From: Abeysekera, Ruwan
Sent: Friday, 26 October 2018 10:18 AM
To: Chowdhury, Abu Sayem
Subject: COMM: TCCS-201834203-23/346 KAMBAH-01 [SEC=UNCLASSIFIED]
Attachments: plans.obr; supporting docs.obr

DEVELOPMENT APPLICATION NO: 201834203

Project Description: PROPOSAL FOR ALTERATIONS AND ADDITIONS TO EXISTING COMMERCIAL DEVELOPMENT – partial demolition of the existing commercial building, alterations and additions to the existing commercial building, landscaping, and associated works.

BLOCK: 23	SECTION: 346	SUBURB: KAMBAH
-----------	--------------	----------------

Figure 2 Main pedestrian areas and active frontages

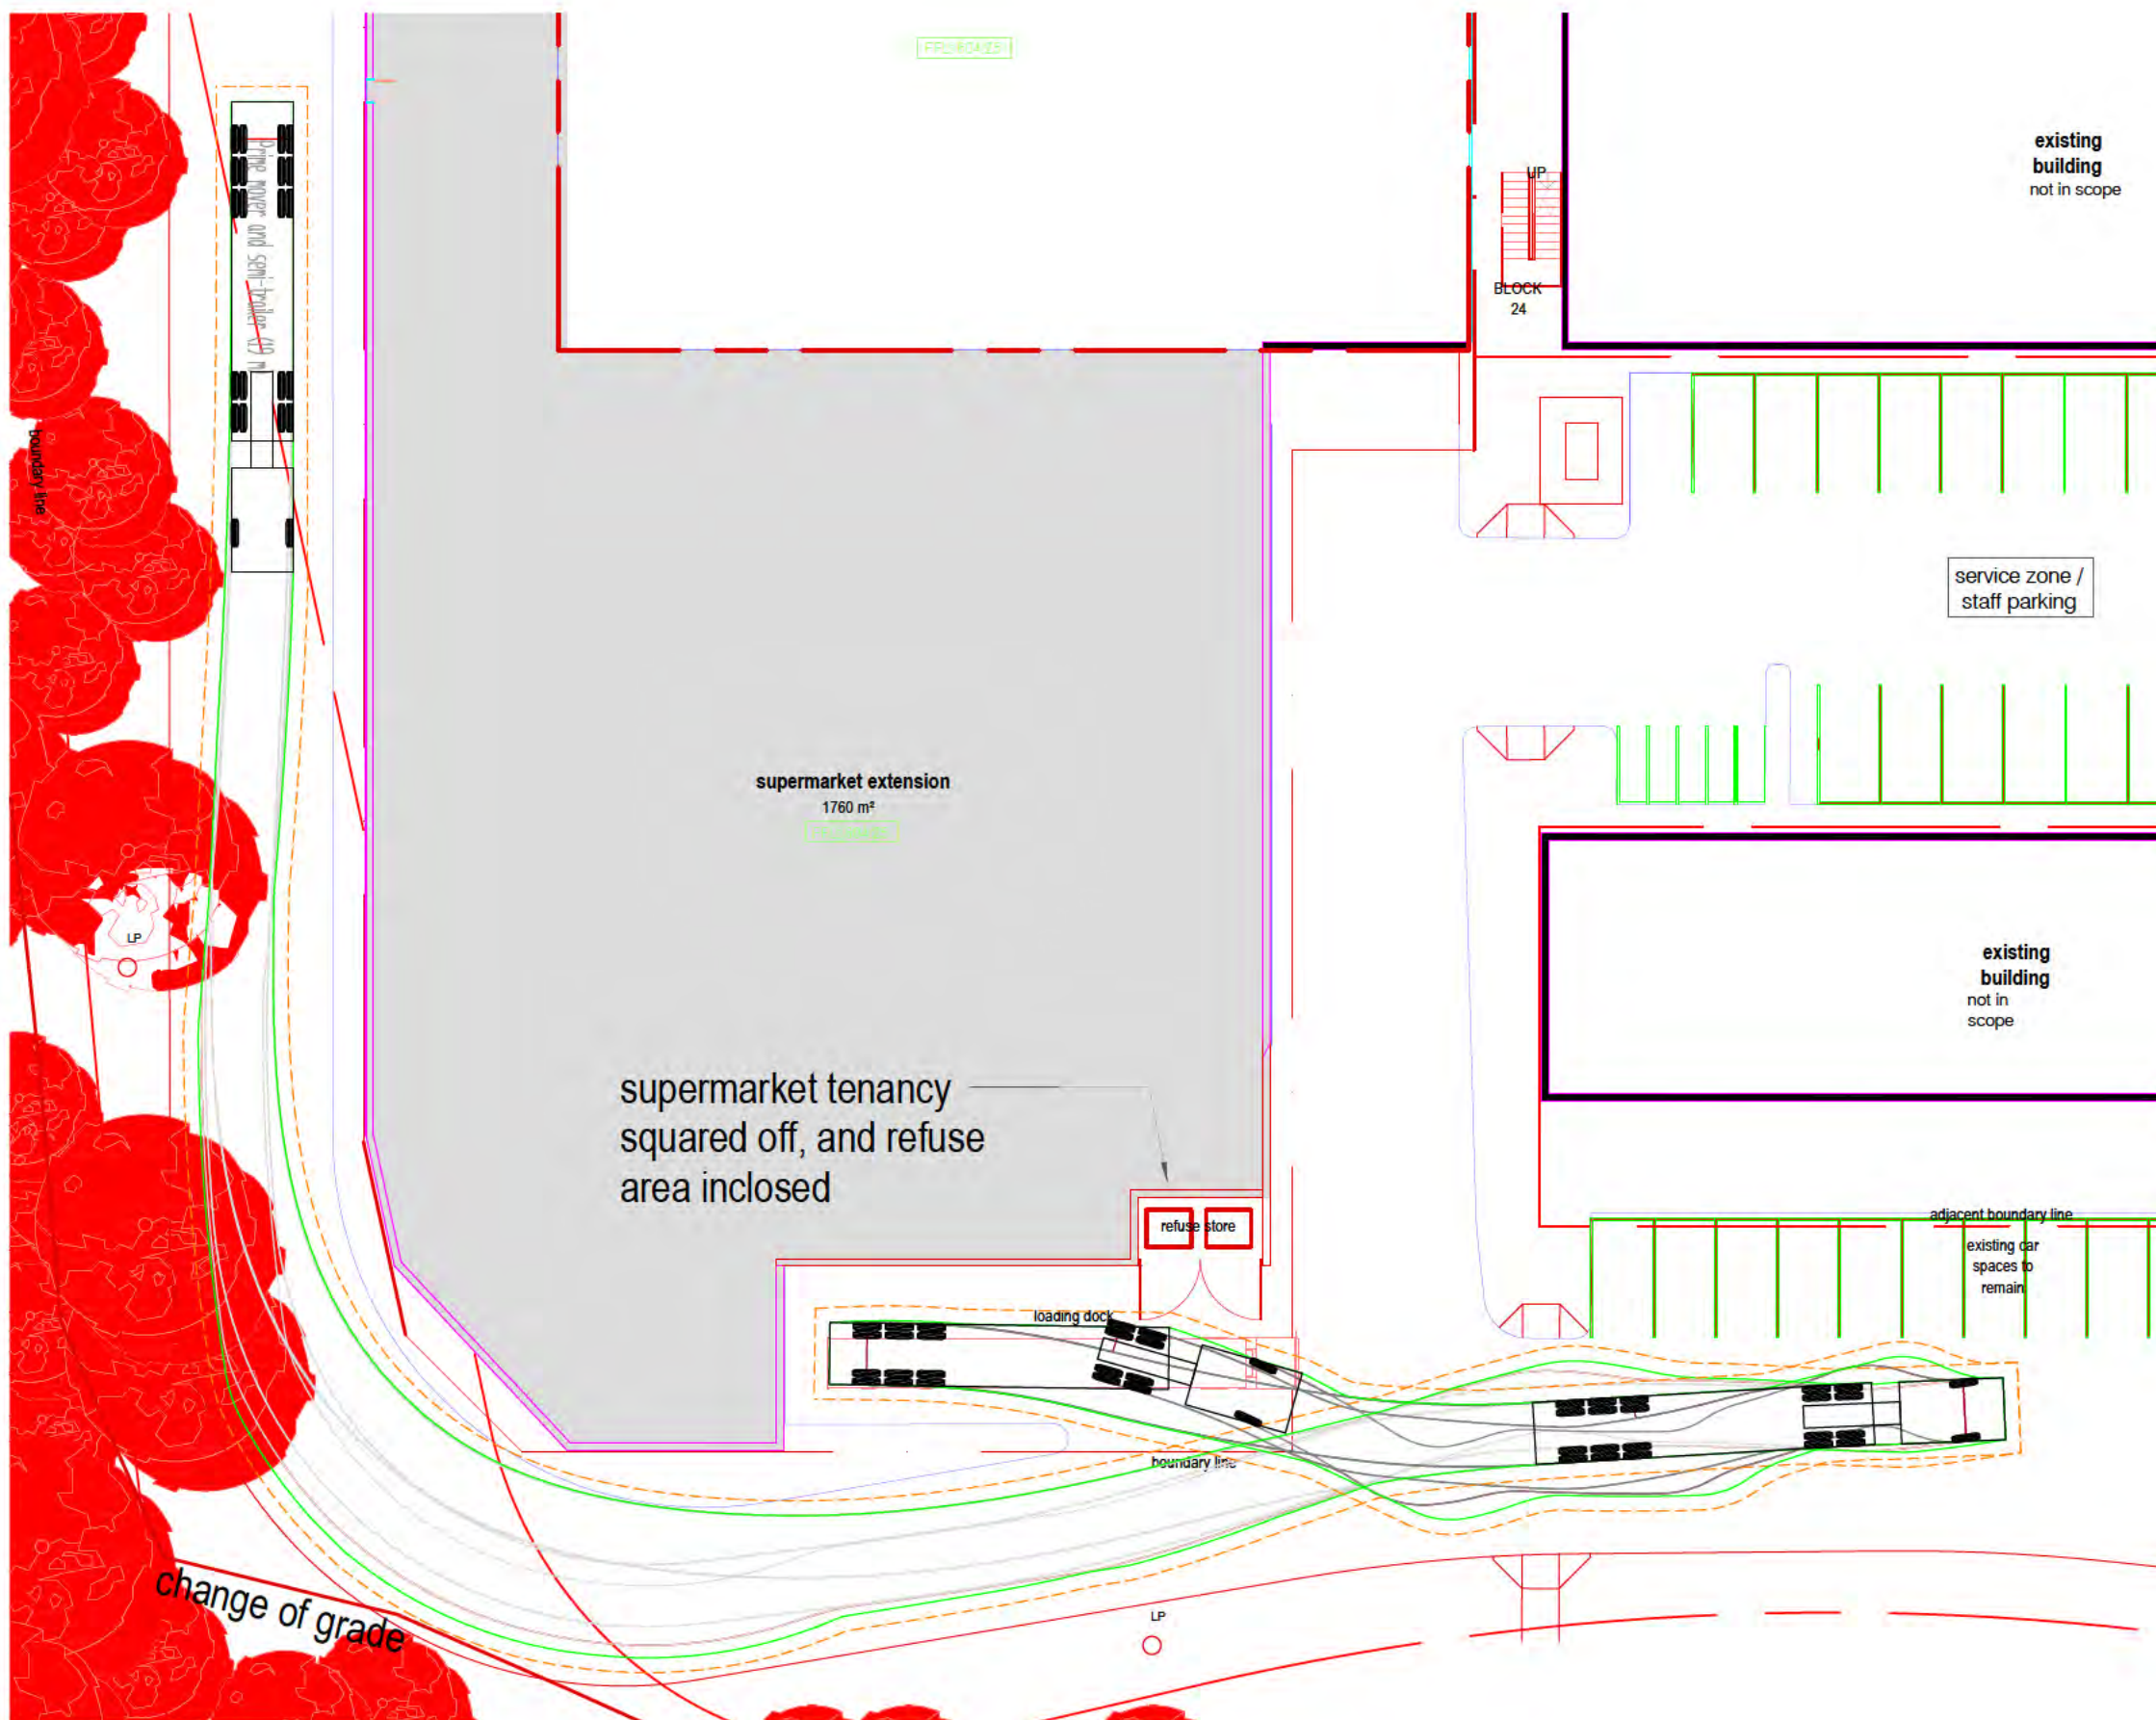
7. The proposed off-site parking being incorporated into this development will need to ensure that these users will be able to access the centre in a safe and accessible manner, including the adequate provision of footpaths and adequate lighting. A plan must show the details of the overflow parking areas and possible routes for pedestrians.

Notwithstanding this further consideration of pedestrian connections from carparks provided to the southern side of the development as part of alternative design/loading area/undercroft carpark. To be discussed with TCCS.

**12.5m HRV USING LOCALIZED LOADING BAY
B99 PASSING**

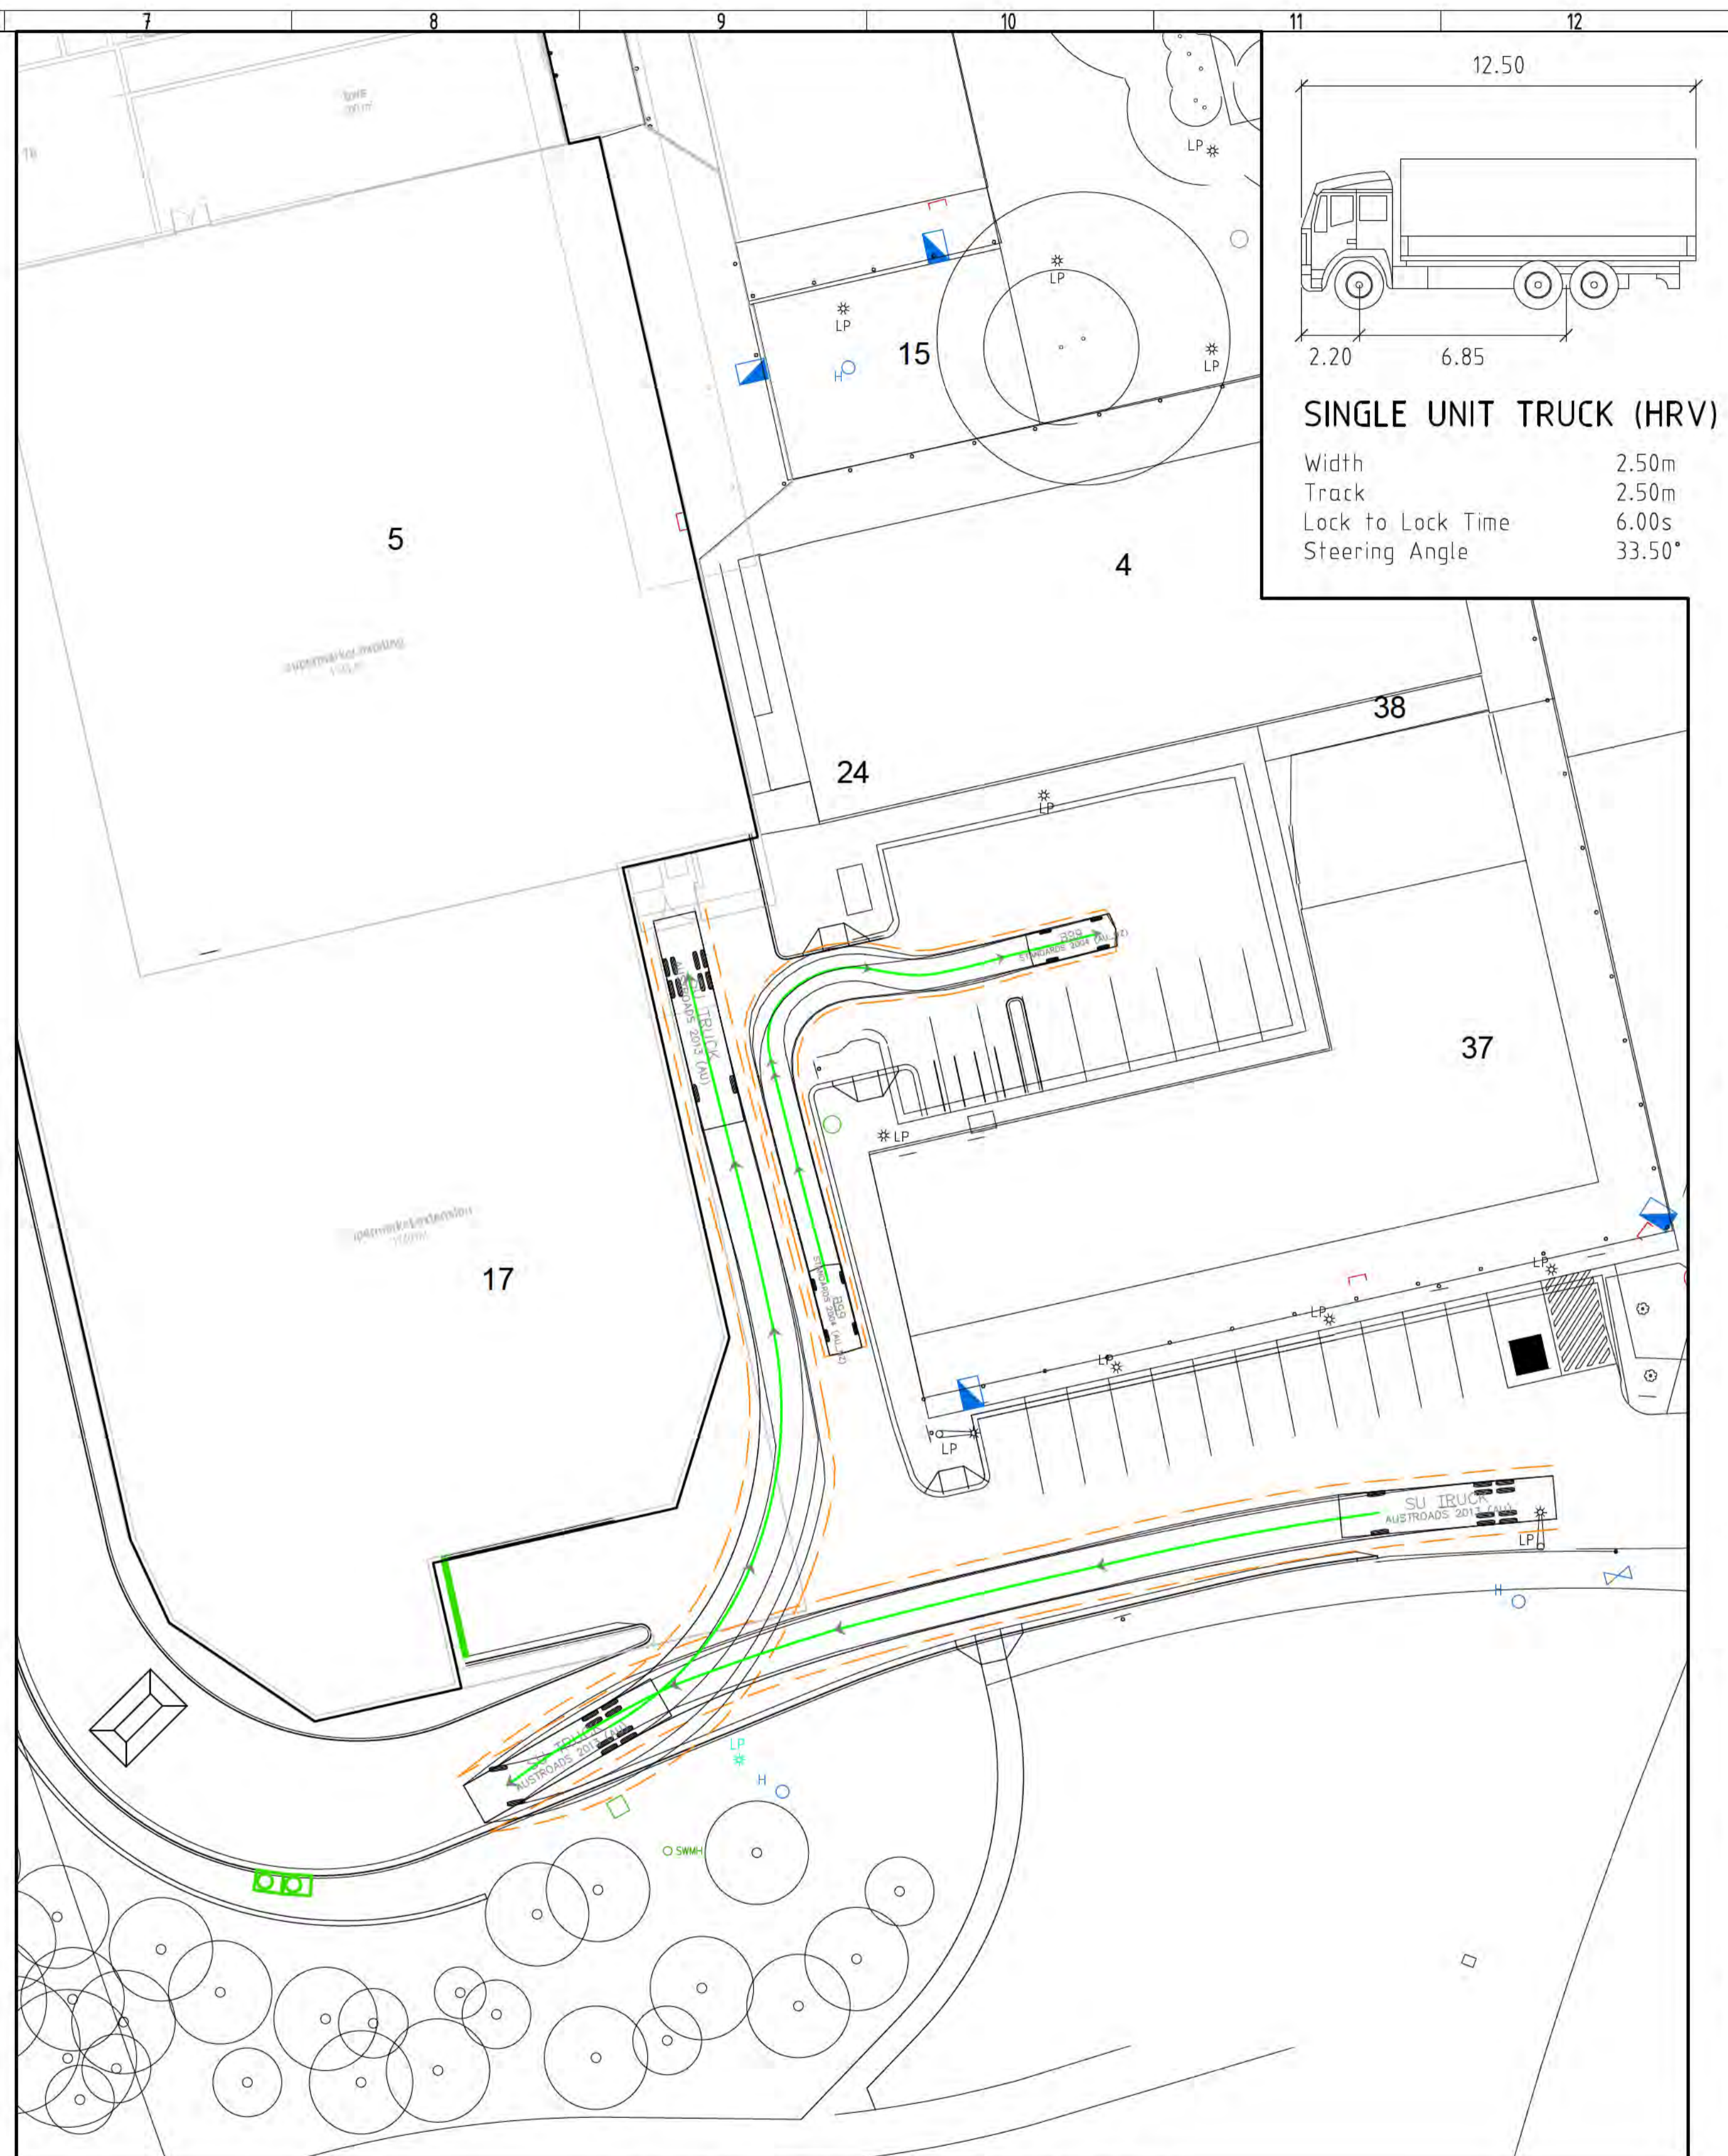
1. The proposed development will restrict service vehicle access to the rear of block 4 and 37. As per submitted vehicle turning template (Drawing C503) it appears that vehicle up to 8.8m will be able to safely access to / egress from the service area. Please refer to the Drawing C505 turning template for 10.5m truck which is too tight to manoeuvre and it doesn't have any clearance available from the wall while reversing out of the service area. The truck will encroach loading dock as well.

2. As per pre DA advice the proponent must consider service vehicle access requirements (size of the largest vehicle currently utilizing the service area) of the businesses in block 4 and block 37 and provide turning template for the largest service vehicle. The proponent needs to submit a written advice from the shop owners in block 4 and 37 as to identify the maximum size of the service vehicle currently being used by the businesses.

No.	Matter	Response	Who	Document to be updated
TCCS				
1	<p>Service Vehicle Access to Block 4 and 37</p> <p>The proposed development will restrict service vehicle access to the rear of block 4 and 37. As per submitted vehicle turning template (Drawing C503) it appears that vehicle up to 8.8m will be able to safely access to / egress from the service area. Please refer to the Drawing C505 turning template for 10.5m truck which is too tight to manoeuvre and it doesn't have any clearance available from the wall while reversing out of the service area. The truck will encroach loading dock as well.</p>	<p>Supermarket waste enclosures will be appropriately screened. Changes are proposed to ensure appropriate access and turning circles are provided into the service areas of block 4 and 37. Please refer to attached turning circle templates. Larger delivery vehicles up to 18m long to be serviced by dedicated loading zone.</p> <p>Proposed to move the waste enclosure for the specialty shops to the western side of the building and provide a loading zone next to the taxi rank to void conflicts with Block 37/4 loading zone.</p>	<p>working with Sellicks on this.</p>
